APPENDIX B - Individual Responses to Charge Questions

The following is a series of comments and recommendations from individual panel members for revision of the preliminary risk assessment and the associated predictive models.

Figure 1

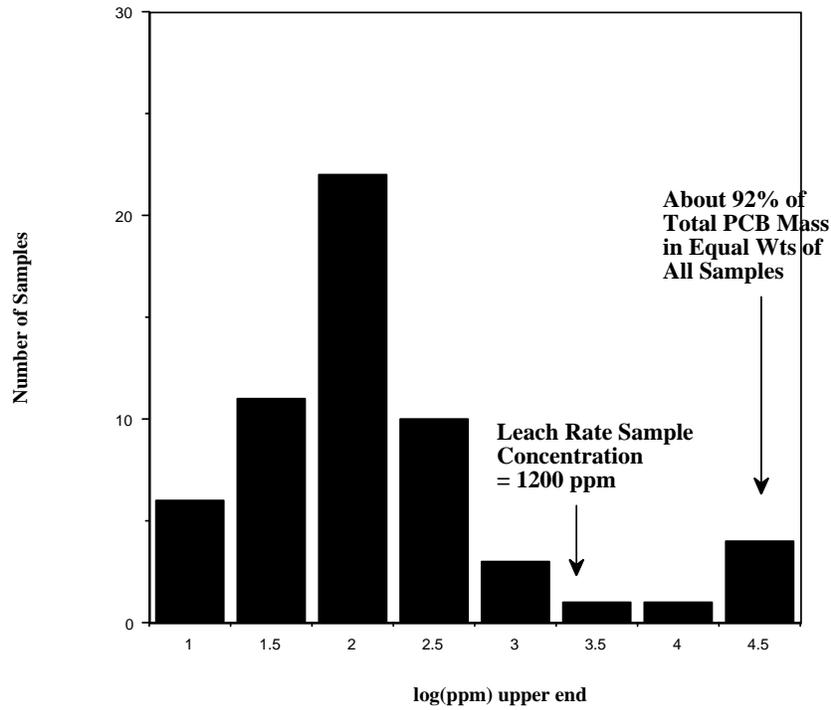
From the central-estimate inventory appearing in the CACI report, over 97% of the total estimated content of the Ex-ORISKANY is in the electrical cable insulation (705.5 lbs/722.6 lbs) = 97.6%). Therefore I decided to check the calculations that led to the estimates of concentration and source release rates from this component of the PCB-containing material. I first plotted the concentrations reported for 59 samples—using two different grouping intervals to make sure that the results are not dependent of the widths or starting points for the intervals I selected (see Figures 1 and 2 (on the following pages). Both plots indicate that, as reported in the PRAM documentation, even after log transformation the distribution departs appreciably from normality. It appears that there are at least two modes, with the high-concentration mode—including 5 of the 59 samples between 10,000 and 29,000 ppm—having about 92% of the total mass of PCBs that would be contained in an equal-weight combination of all 59 samples. Unfortunately, the one sample of cable studied in the leaching experiments contained only about 1200 ppm PCBs (0.12%). This means that the representativeness of the single sample used for electrical cable leaching rates is very questionable. A higher concentration electrical cable sample—which would be more representative of the material containing the vast majority of the PCBs on the ex-ORISKANY—is likely to have a larger fractional rate of

release of PCBs into sea water, meaning that the principal PCB source driver for the PRAM model is likely to have been substantially underestimated—with corresponding effects on concentration levels in different media, biota, and ultimate risks.
